SUBJECT: Forwards marked-up Unit 2 Tech Spec pages, used to prepare draft Tech Specs for Unit 3. Advises that present Unit 3 schedule for fuel loading necessitates approval of Tech Specs by 870301.

Subject: Palo Verde Nuclear Generating Station (PVNGS)
Unit 3
Docket No. STN 50-530
Draft Technical Specifications
File: 86-F-005-419.05; 86-D-056-026

Enclosed are marked up PVNGS Unit 2 Technical Specification pages with justification, used to prepare the draft Unit 3 Technical Specifications. The changes presented herewith represent typo's, editorial comments, unit specific and technical changes to the Unit 2 Technical Specifications. The Unit 2 Technical Specifications that have not changed will be used as the basis for the remaining Unit 3 draft Technical Specifications as previously discussed with your staff.

FIGURE 3.1 - 1A

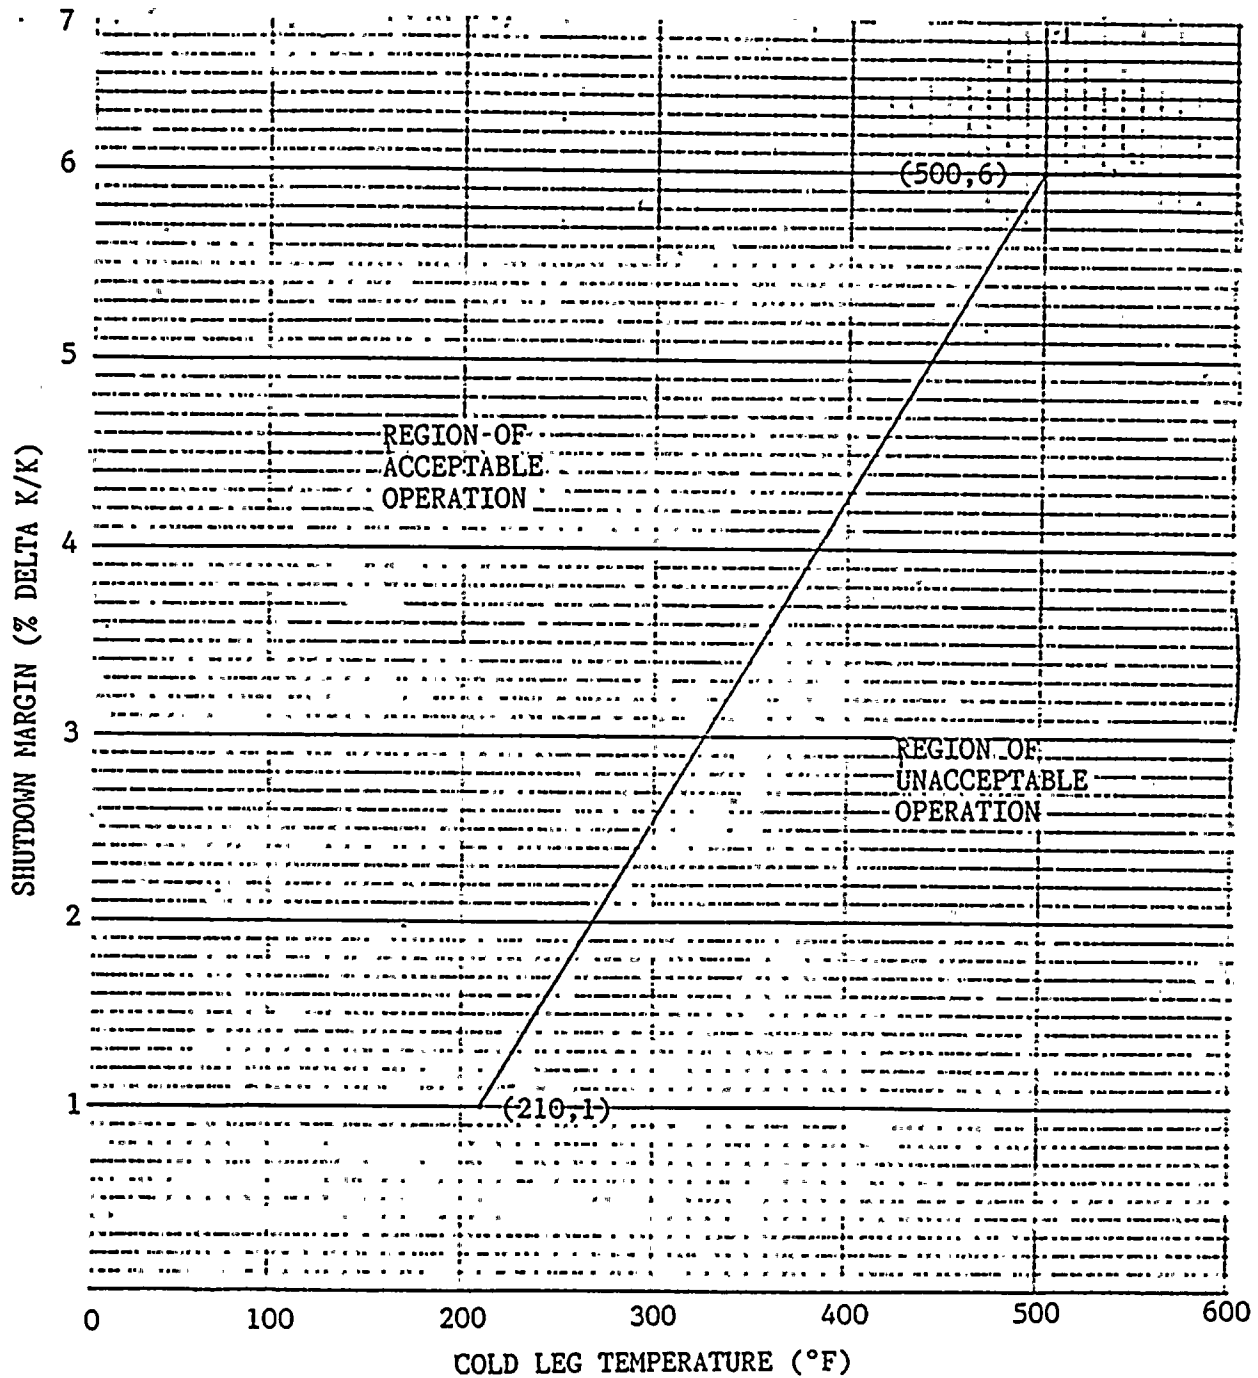
3.1.1.2^a The SHUTDOWN MARGIN shall be greater than or equal to 4.0% that shown in ~~delta k/k~~ Figure 3.1-1A, and

4.1.1.2.1 The SHUTDOWN MARGIN shall be determined to be greater than or equal to 4.0% ~~delta k/k~~ that in Figure 3.1-1A:
